Rain Garden Deficiencies

31 Bristol Road

34 Bristol Road

Proposed typical layout on approved site drawings.

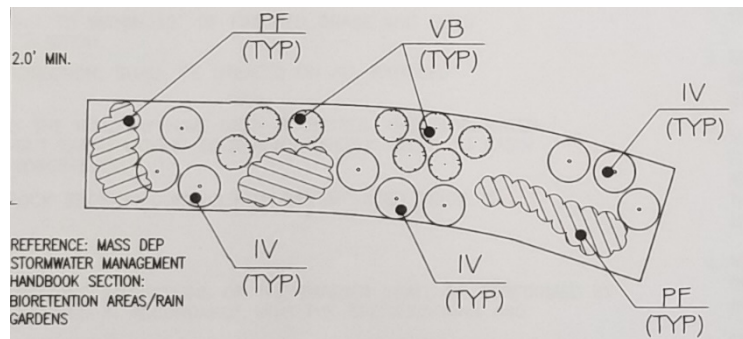
The specifics of the design for a rain garden are based on the size or volume of the rain garden is based on the amount or size of the area you want to drain to it. The design manual suggests it should be between 5-7% of the area draining to it. Unfortunately, the design of the rain gardens did not reflect the final site plans or the final slopes or elevations of the site. Basically, the gardens were way too big, and the site elevations were steeper than they should have been.
